# UNITED STATES PATENT AND TRADEMARK OFFICE

APPLICATION NO.	FILING DATE	FIRST NAMED INVENTOR	ATTORNEY DOCKET NO.	CONFIRMATION NO.
10/669,460	09/25/2003	Jong Dam Kim	2658-0309P	4600
2292	7590	05/27/2005	EXAMINER	
BIRCH STEWART KOLASCH & BIRCH PO BOX 747 FALLS CHURCH, VA 22040-0747			CHAN, EMILY Y	
			ART UNIT	PAPER NUMBER
			2829

## Office Action Summary

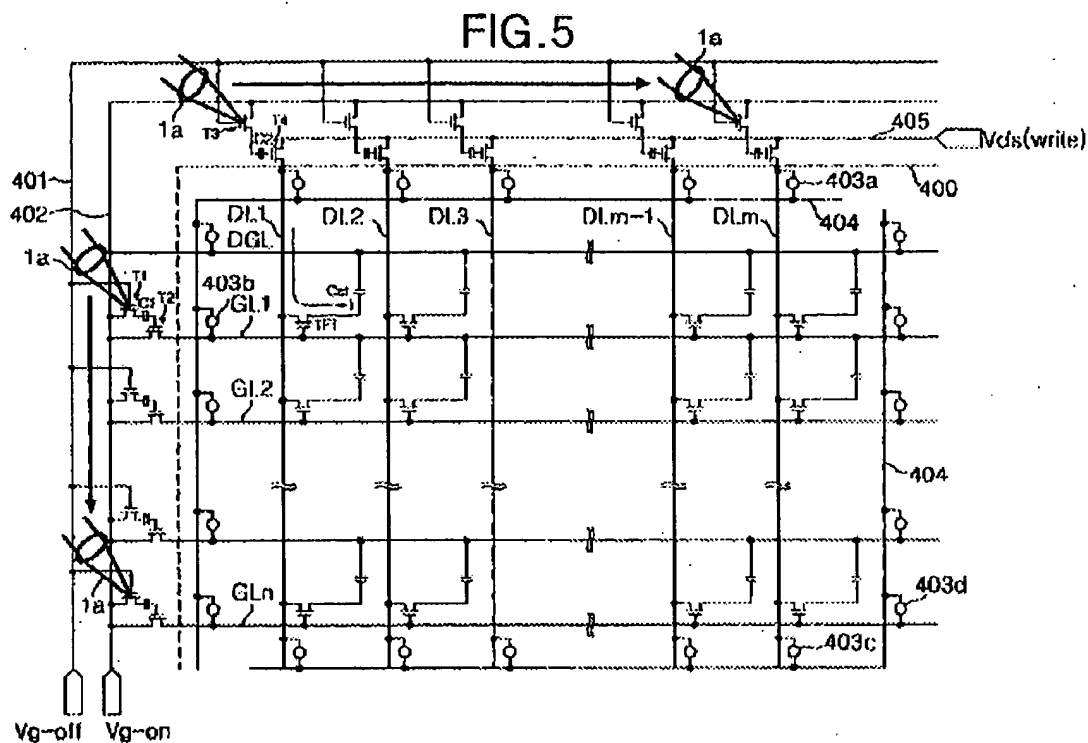
Independent claims 1, 17 and 29 and dependent claim 10 are allowed because the prior art of the record does not teach or suggest an apparatus for a liquid crystal display device and a method of inspecting a liquid crystal display device comprising a light source to radiate light onto at least one inspection switch device and thereby supplying an inspection voltage from the at least one inspection line to a corresponding one of the drive switches through the signal wirings, so as to charge a corresponding one of the capacitors as shown by Fig 5 1a below.
